Crookwell 3 Wind Farm

Landscape & Visual Impact Assessment Supplementary Report

Response to Independent Expert Review
Ref: 918-Z-02, Dated August 2013

22 January 2014

Figure SR1
Distance effect

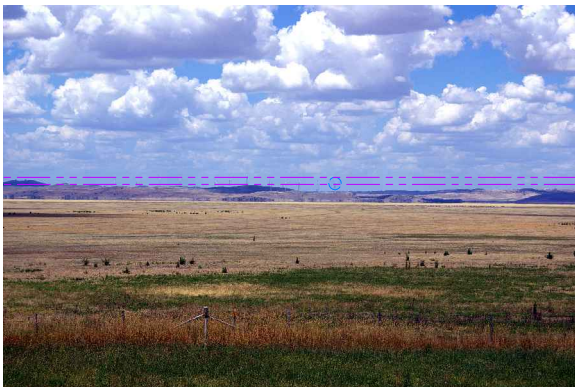
- ***an assessment of the effect of proposed turbine height on dominance and required setbacks in the study area landscape***

The effect of proposed turbine height on dominance in the Crookwell 3 LVIA was informed by the initial findings indicated in the Sinclair-Thomas Matrix (2001) included in the Scottish Natural Heritage 2002 Visual Assessment of Wind Farms: Best Practice report. These findings have been modified to account for degrees of professional judgement based on reviews of wind farm developments and field inspections carried out by GBD at a number of constructed and operational wind farm developments within Australia.

With an increase in distance the proportion of a person's horizontal and vertical view cone occupied by a visible turbine structure, or group of turbine structures, will decline. In order to demonstrate this a series of single frame photographs have been taken from pre-set distances (1.5 km, 4 km, 7 km and 10 km) toward wind turbines at the Capital wind farm in New South Wales. The photographs, illustrated in **Figure SR1**, demonstrate the degree to which the apparent visible height of a wind turbine decreases with increasing distance (in a negative exponential relationship), and the increasing amount of horizontal skyline visible with an increasing distance.

Whilst GBD do not dispute Bishops findings in the determination of thresholds of visual impact, GBD consider that professional judgement based on field inspections at multiple wind farm developments is as valid as the interrogation of sixty one Melbourne University students and staff viewing computer simulations.

Figure SR2
Residential View Locations

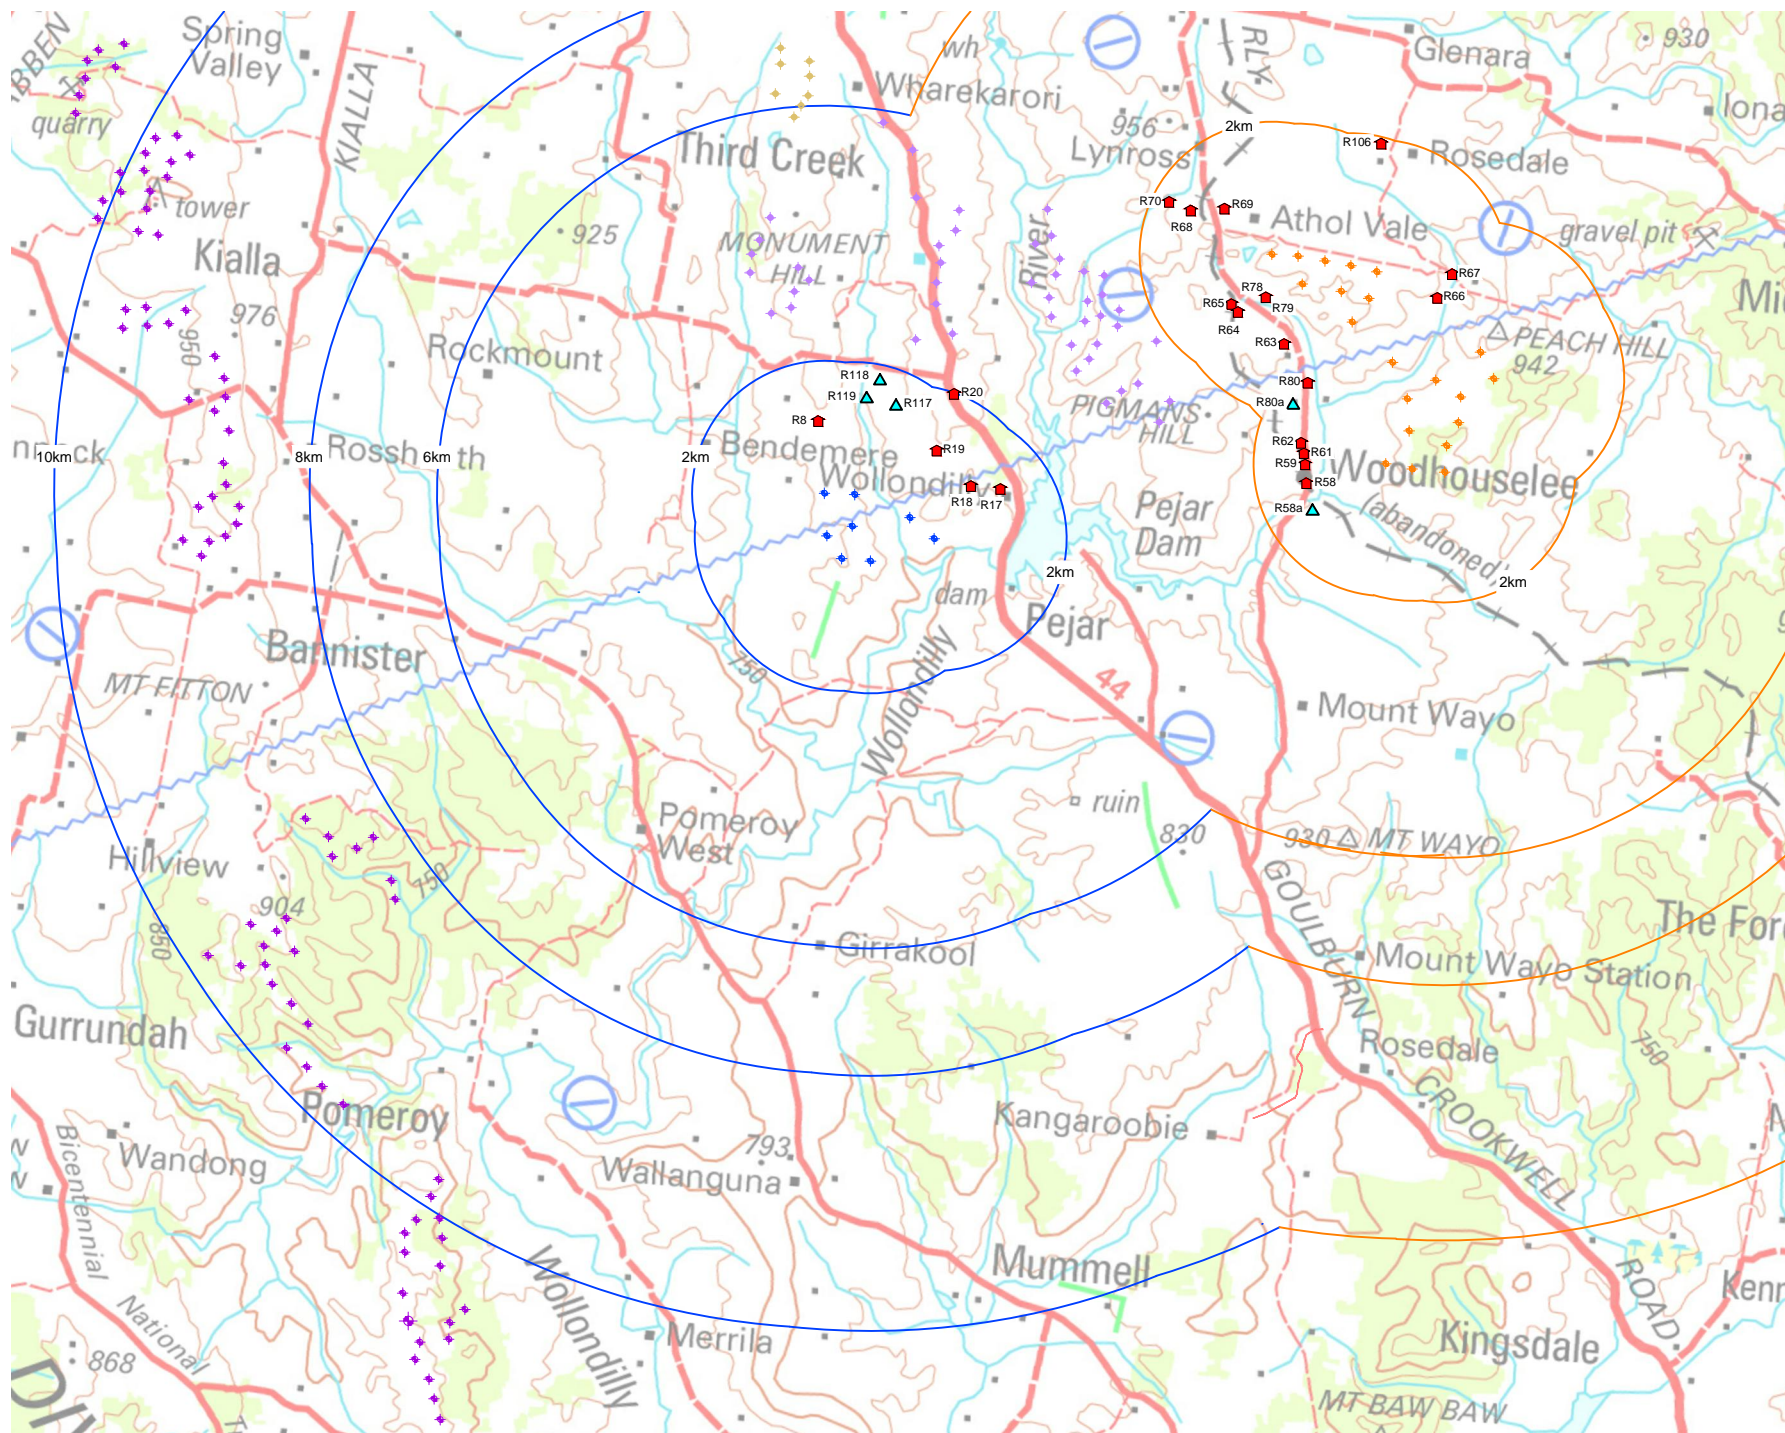
- ***Provide a justified methodology and assessment of the cumulative impacts of Crookwell 3 combined with Crookwell 1, 2 and Gullen Range including both approved and proposed elements;***
- ***Clearly identify any likely changes to the landscape character of the region resulting from the combination of the regional projects and identify the regional community perceptions of the resultant cumulative impacts based on surveys and consultation, and***
- ***Include assessments of the cumulative impact of the regional projects on public viewing locations, heritage items and individual residences, particularly residences within 2 km of any proposed Crookwell 3 wind turbine.***

The location of the residential dwellings within 2 km of the Crookwell 3 wind turbines are illustrated in **Figure SR2**.
